# **City of Laredo**

**Historic District / Landmark Board**

**Meeting Date:** 3/12/2026

**Action Item 6A.**

2 EXISTING EAST BLDG ELEVATION

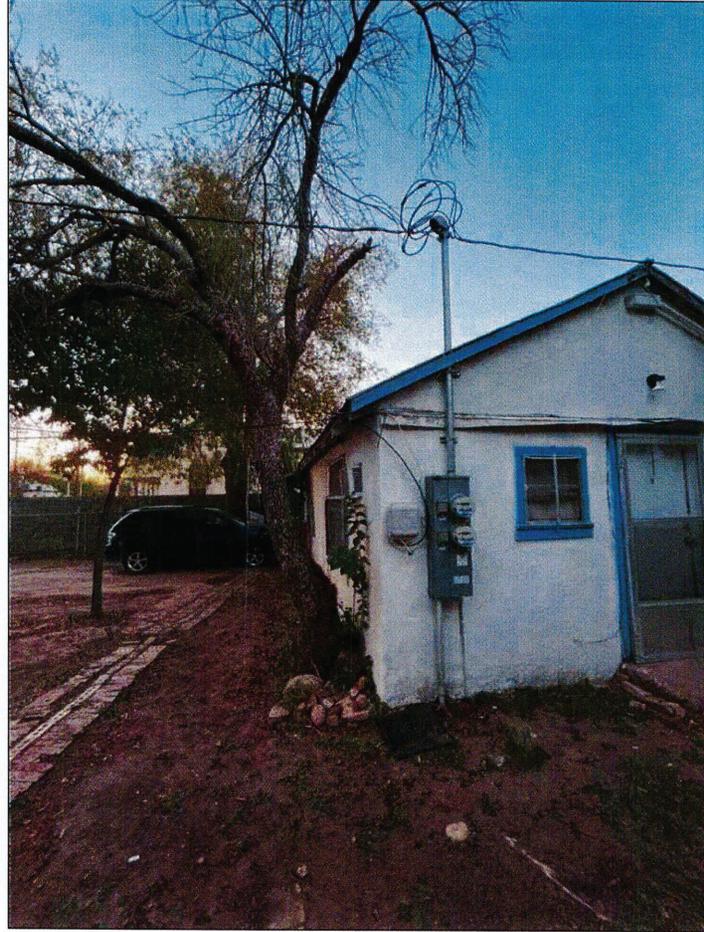
Staff supports the installation of the solar panels on the existing roof for the following reasons:

1. Installation of solar panels on the existing roof are low-profile, minimally visible, reversible, and do not require removal of significant historic materials.

- Roof-mounted panels should not require removal of historic roofing materials beyond what is necessary for attachment and should avoid altering the historic roof form, pitch, or visible architectural detailing. (Standard 2 and 5)

- Solar panels will be low-profile, mounted flush with the roof plane, and placed in a manner that minimizes visibility from the public right-of-way, particularly on primary elevations. (Standard 9)

- The panels and mounting system should be installed so that, if removed in the future, the essential form and integrity of the historic roof would remain intact. (Standard 10)

# EXAMPLES OF THE SOLAR PANEL PERGOLA TO BE INSTALLED

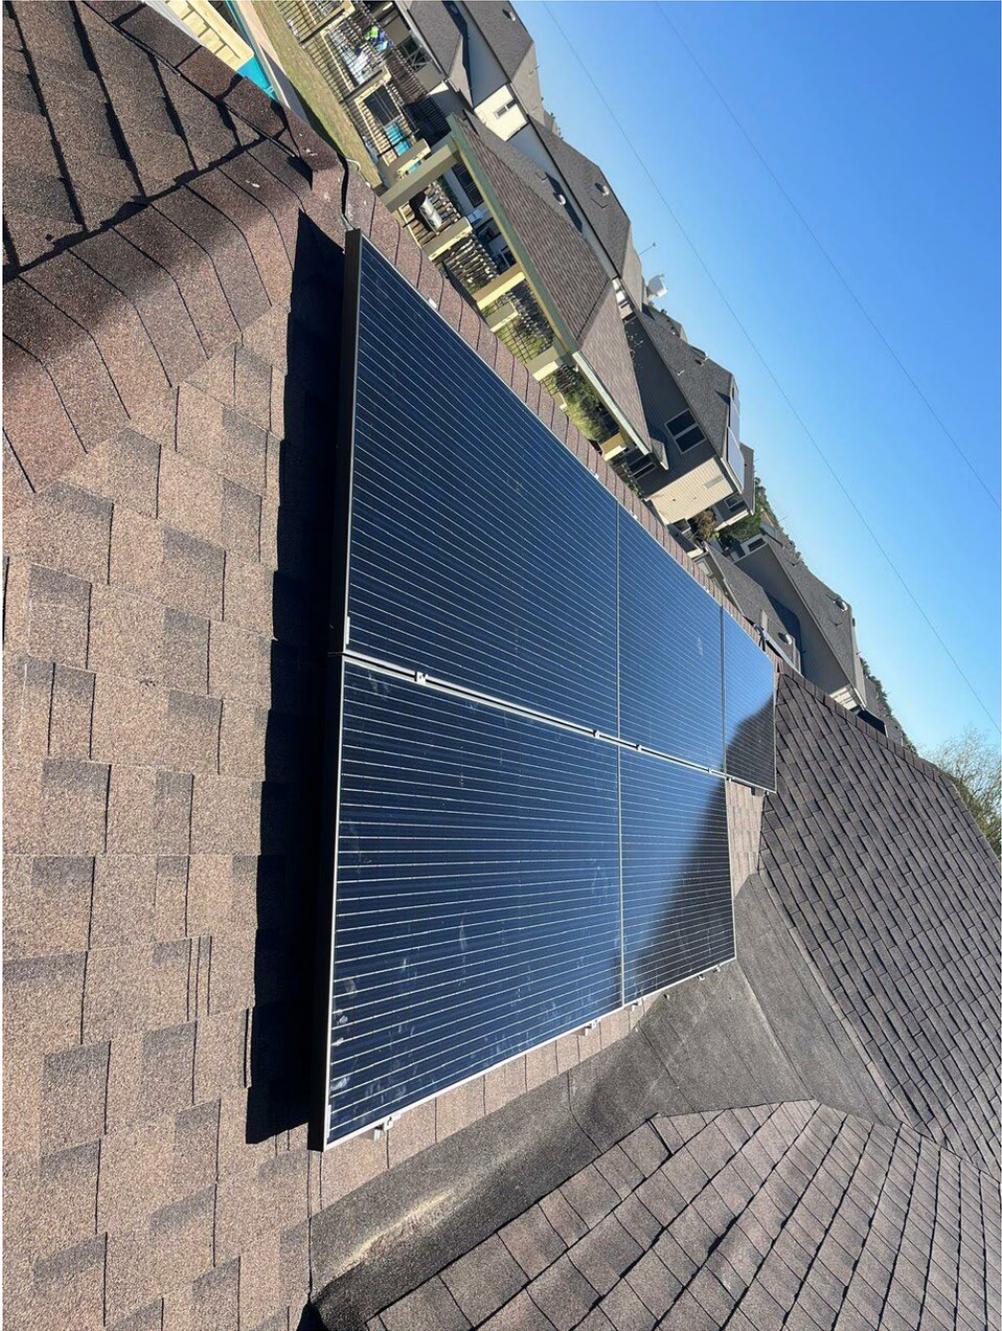
Staff supports the proposed new construction of the solar panel pergola for the following reasons:

1. Construction of a new solar panel pergola in the front yard will not adversely affect the historic character, setting, and spatial relationships of the property.
  - The proposed solar panel pergola is a freestanding structure and does not require alterations to the historic materials, features, or architectural elements of the residence. As such, the defining characteristics of the historic home will remain intact. (Standard 2)
  - The proposed pergola structure is not physically attached to the historic residence. As a result, if the pergola were to be removed in the future, the essential form, materials, and integrity of the historic residential structure and its environment would remain unimpaired. (Standard 10)
